SI B26 01 14
Driveshaft

August 2014
Technical Service
SB-10056722-1782

This Service Information bulletin supersedes SI B26 01 14 dated June 2014.

Service Action: Inspect Front Driveshaft

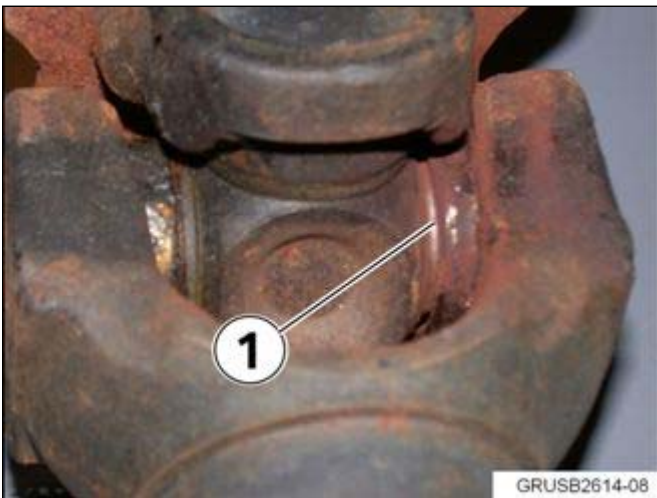
Check the universal joints in the front driveshaft for radial play (1).
Note: The E72 will need to have the reinforcement plate removed to check the driveshaft U-joints. Refer to Repair Instruction 31 10 010, "Removing and installing/replacing reinforcement plate."

1. Checking the front U-joint:

Hold the input flange (1) on the front differential and check for radial play in the U-joint (2). There should be no excessive play.

2. Checking the rear U-joint:

Hold the output flange (1) on the transfer case and check for radial play in the U-joint (2). There should be no excessive play.

3. Rotate the driveshaft 90° and repeat steps 1 and 2. Rotate the driveshaft another 90° and recheck for play. Rotate a total of four times (the driveshaft has now been rotated 360° total). There should be no excessive play in the U-joints.

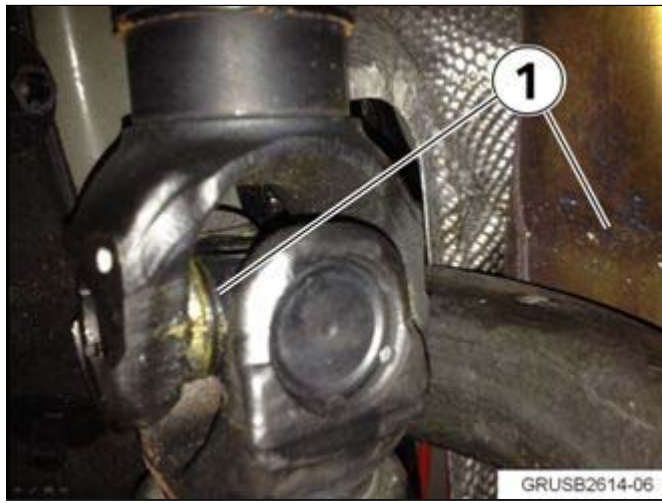
NEW If no play is found in the U-joints, a visual inspection of the U-joint needle bearing seals on both front and rear U-joints will be necessary.

1. **NEW** There should be no cracking or damage at the bearing seals (1).

2. **NEW** There should be no exposed needle bearings (1).

3. **NEW** There should be no excessive rust at the bearing seals (1). Note: There will be rust buildup on the driveshaft and mounting flange on some driveshafts. This rust is normal. Only excessive rust on the bearing seals indicates the seal may fail.

4. **NEW** Also check for excessive grease marks on the surfaces of surrounding components around

the U-joints and for excessive grease released out of the bearing seals (1).

NEW If any of the above conditions are present, replace the driveshaft. Refer to Repair Instruction 26 20 000, "Removing and installing front propeller shaft as of 4/2010."
